Suffolk County Council (20041323)
Babergh and Mid Suffolk District Councils (20041302)

Local Impact Report: Annexes A to F
Bramford to Twinstead (EN020002)

A Babergh and Mid Suffolk District Councils and Suffolk County Council Position Statement on the Bramford to Twinstead Project - Assessment of Effects in the Brett Valley, 2013

**Bramford to Twinstead Project
Assessment of effects in the Brett Valley**

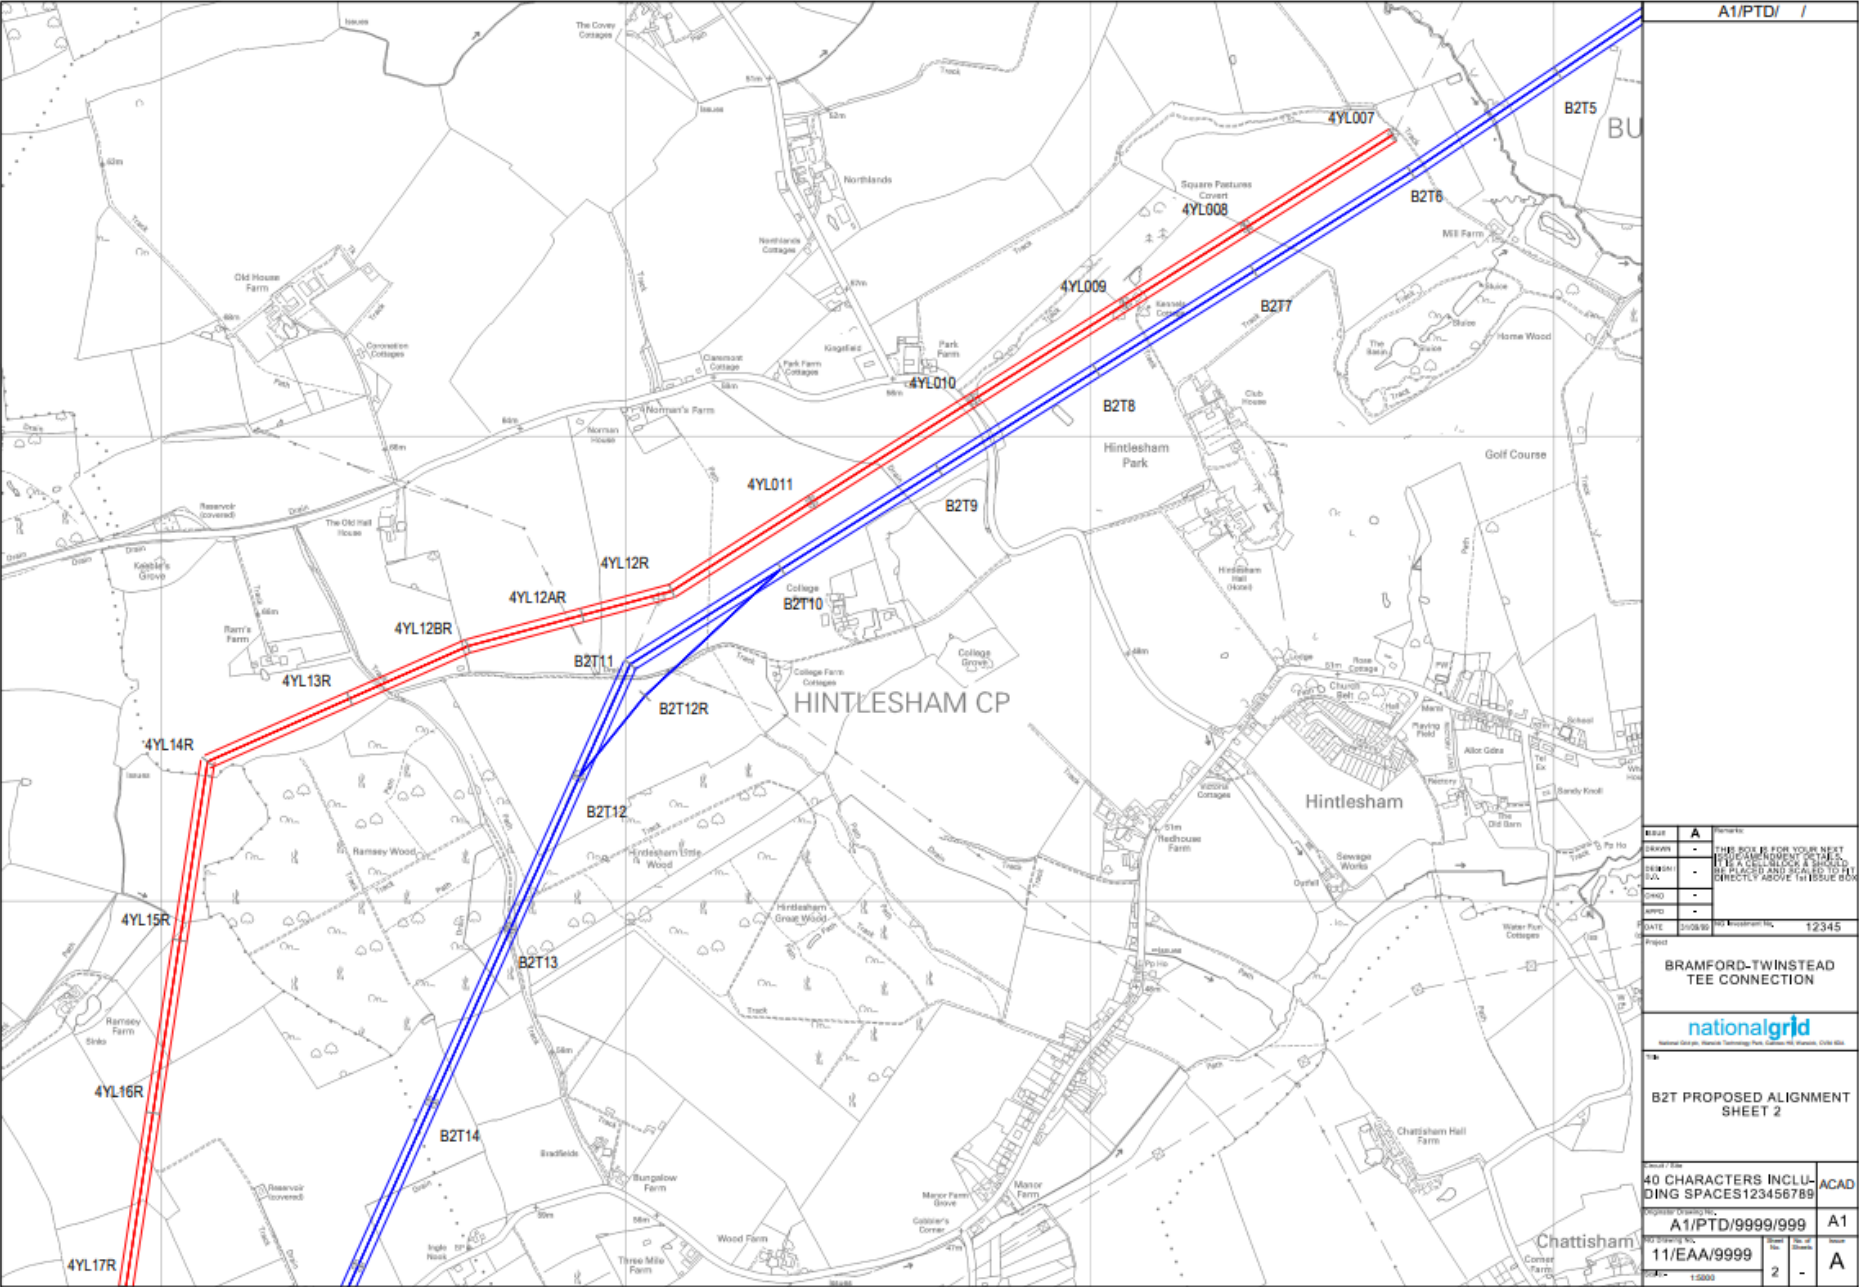
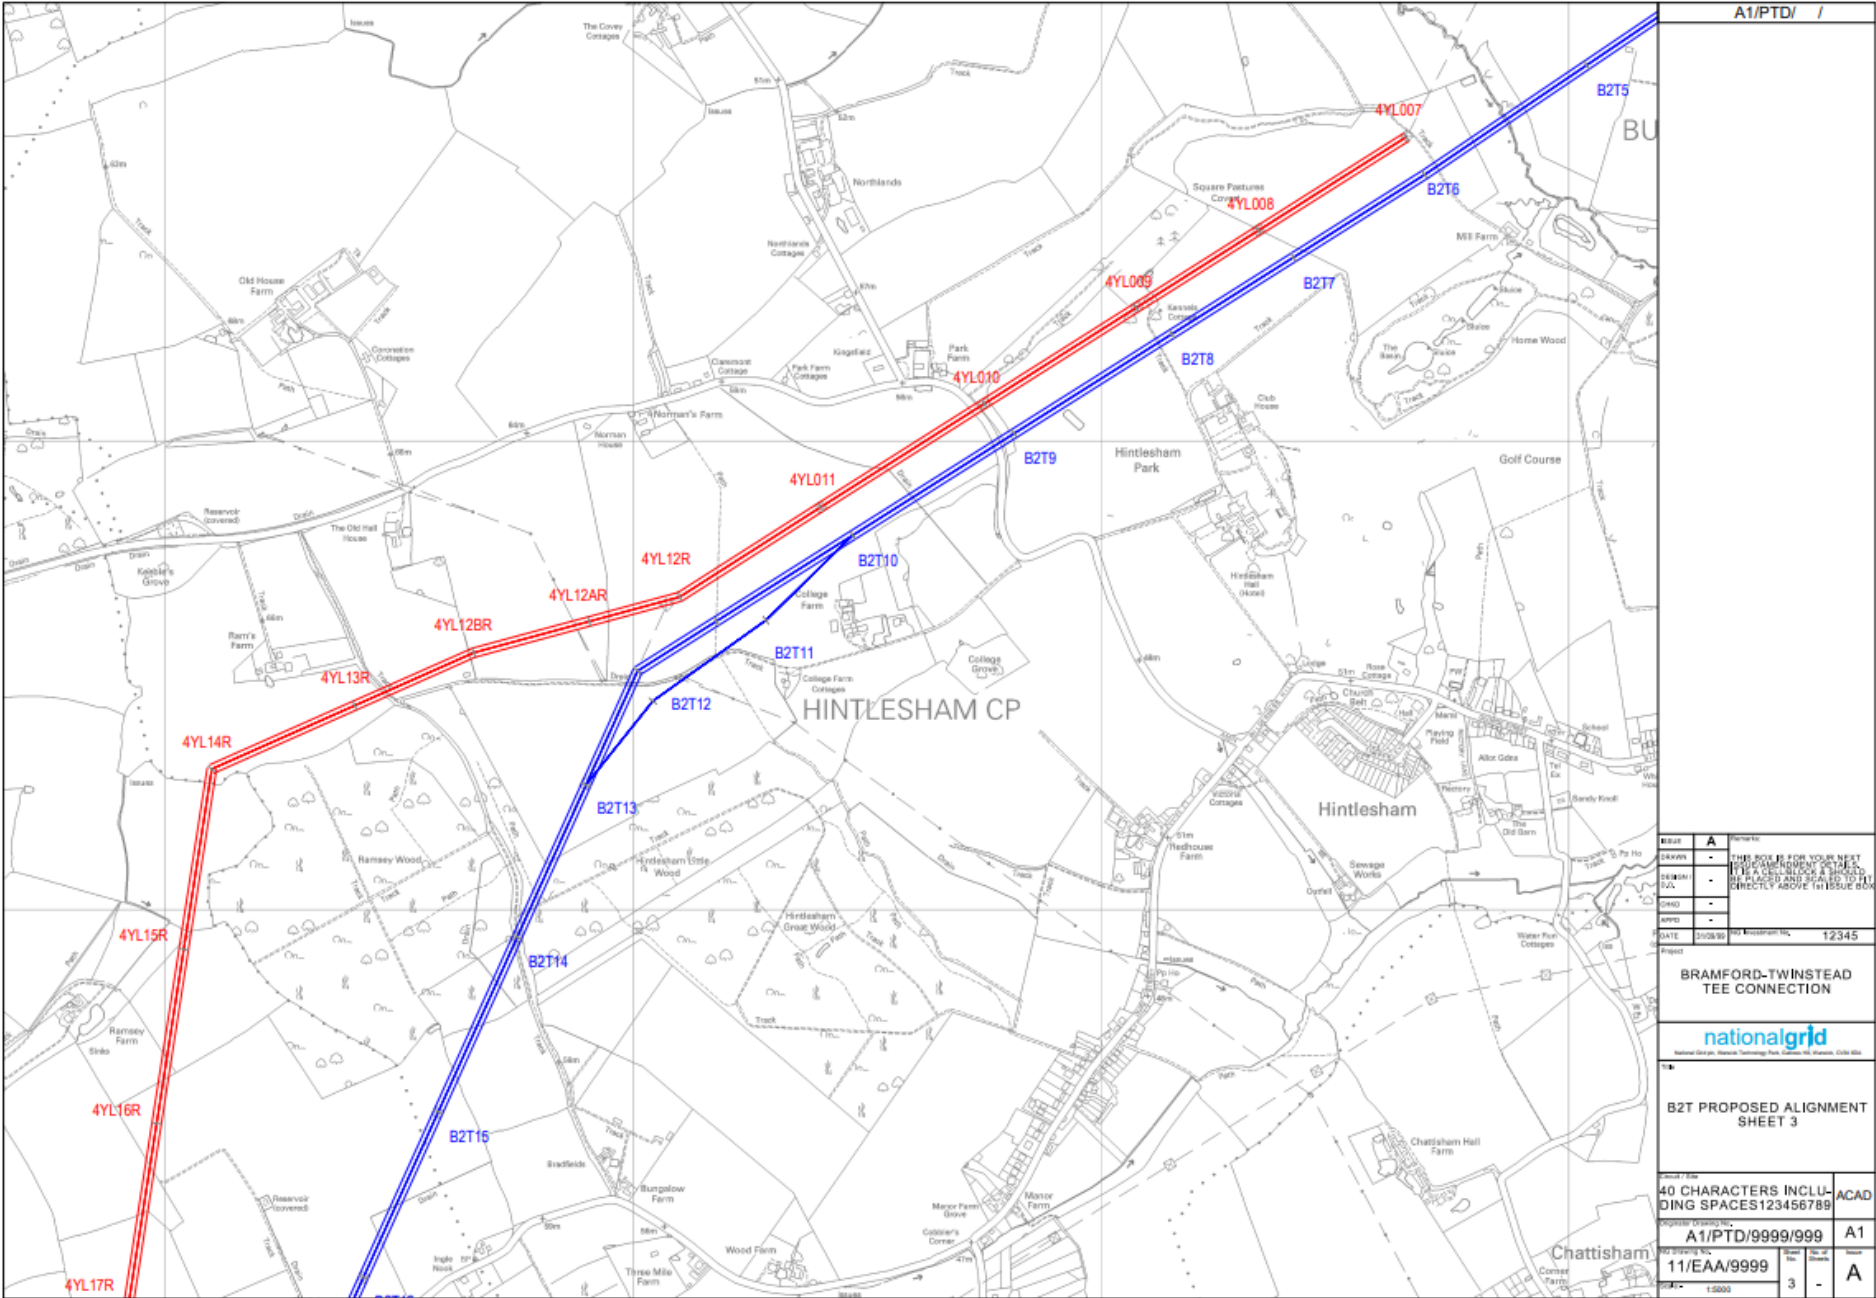
The local authorities accept that Option Three would marginally reduce the impact of the scheme upon the setting of Hintlesham Hall a Grade 1 listed building and lessen the impacts upon other listed buildings, notably College Farm and the visual amenity enjoyed by residents of that property. This option also reduces the impact on Square Pastures covert.

National Grid has outlined some limited mitigation proposals to reduce the impact of the scheme upon the setting of Hintlesham Hall and the surrounding landscape however notwithstanding these revisions the local authorities remain firmly of the view that the capacity of the receiving environment to undergo further change without compromising the setting of Hintlesham Hall is already very limited if not non-existent.

While Option Three and the associated mitigation measures are welcome, the local authorities do not consider that they are commensurate with the scale of the impacts that would be created by the proposal. As stated in the Position Statement the interaction of the proposed scheme with the baseline (existing line) does not appear to have been fully taken into account. Indeed National Grid acknowledges that overhead lines exist (subject to periodic refurbishment) "in perpetuity".

The local authorities therefore consider that the additional overhead line should be placed beneath ground in this section of the route.
